B737 PTU Cracked Seal Retainer Investigation PN 56586

P/N:63169 – Rev. A (Mar-2026)

Problem Statement:

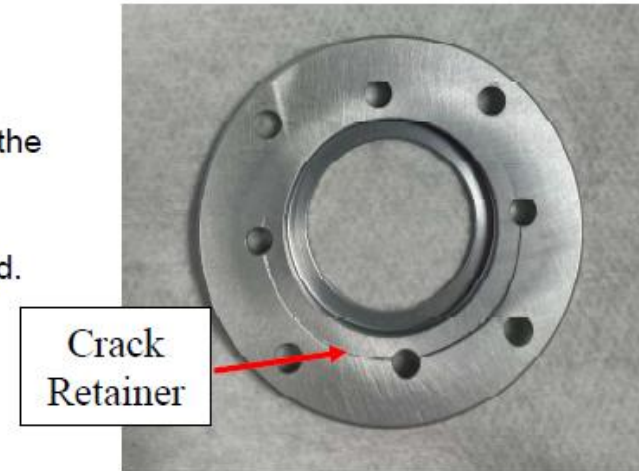
- Increase of PTU returns due to external leakage
- After teardown for investigation, units present cracked seal retainer on the motor side
- Oftentimes the screw heads are busted off and internal seal is damaged.

Failure Sequence:

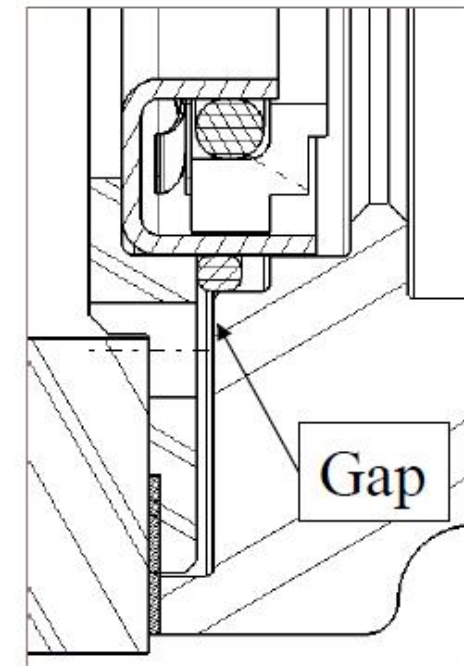
1. Screw Heads Break
2. Retainer moves toward bracket and destroys the gasket.
3. With the gasket damaged, the internal seal has a 0.023" gap.
 - Seal extrudes out un-used hole.
 - Even without un-used hole, seal is expected to extrude.
4. Retainer cracks
 - Supported by FEA
 - Different predicted life depending on location
 - 0-600-0 psi, 300,000 cycles
 - 13,302 cycles predicted in exterior radius of retainer.

Retainer Crack Locations:

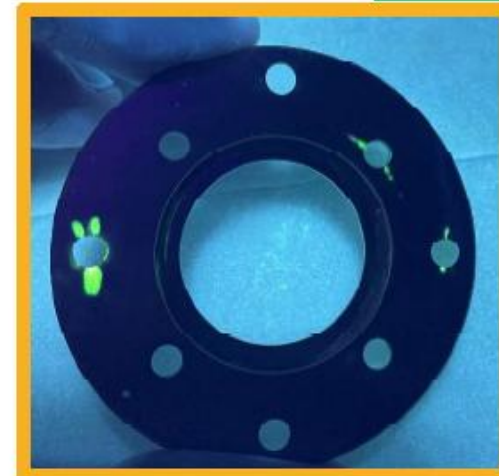
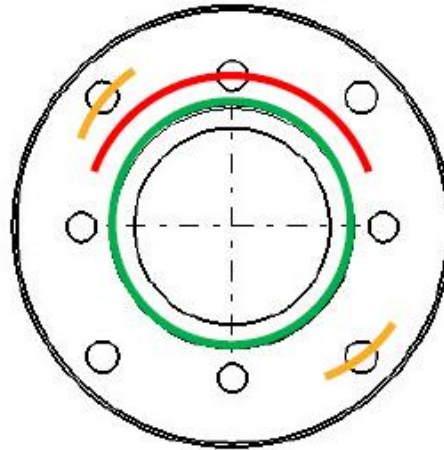
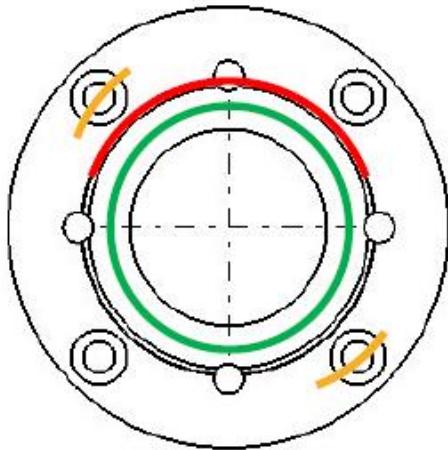
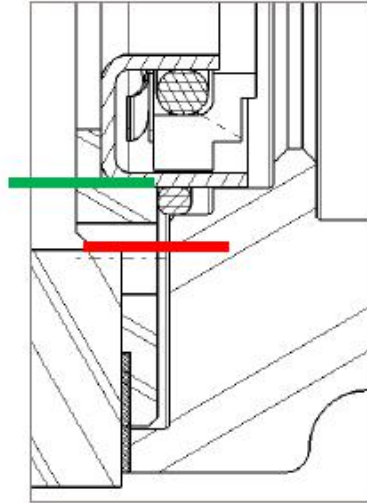
- Screw Location
- Exterior Radius
- Internal Shaft Seal Shelf

Proposed Interim Fix Improvement

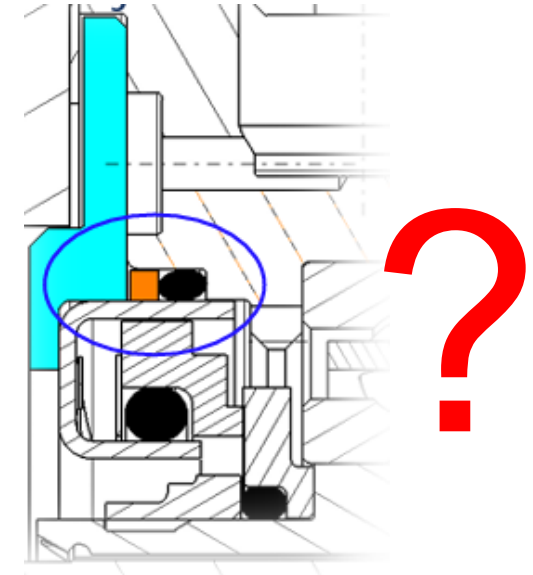
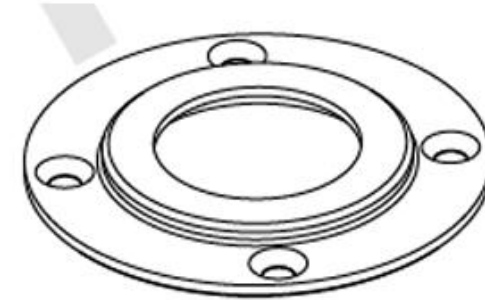
- Option A: Strengthen seal retainer via material change to steel, remove non-used holes, and increase lip radii.
- Option B: Install backup-ring to existing O-ring seal between housing and cup seal to further prevent seal extrusion if screws break.
- ECD: Middle of 2026

Known Issues – Potential Redesign:

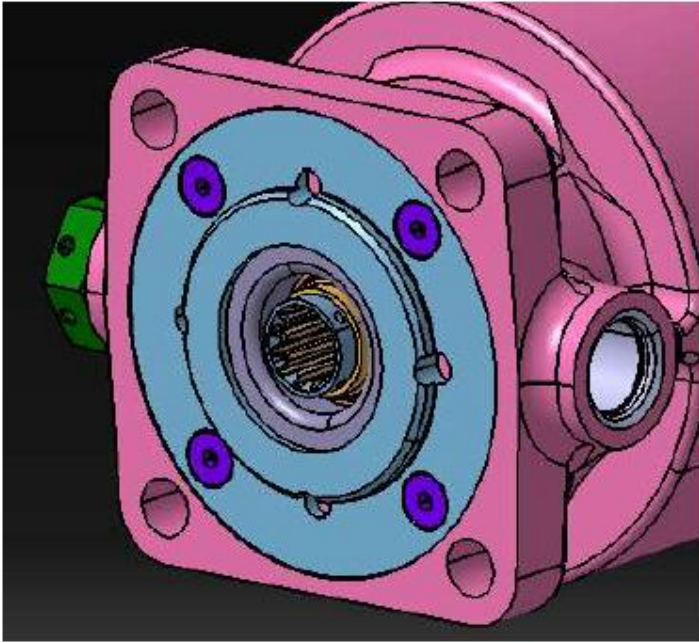
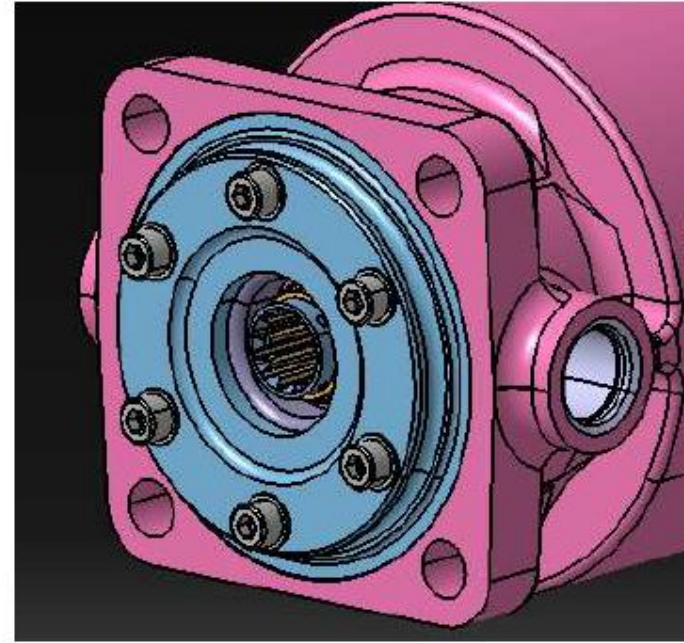
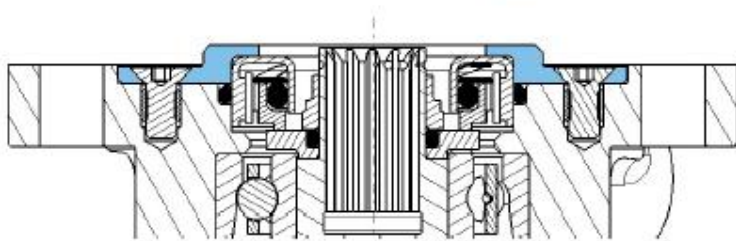
- Seal Retainer Cracking – Replace 4 counter-sunk holes with 6 through holes. Incorporate outer o-ring gland. Increase flange thickness. Evaluate integration of shaft seal Cup with Seal Retainer.
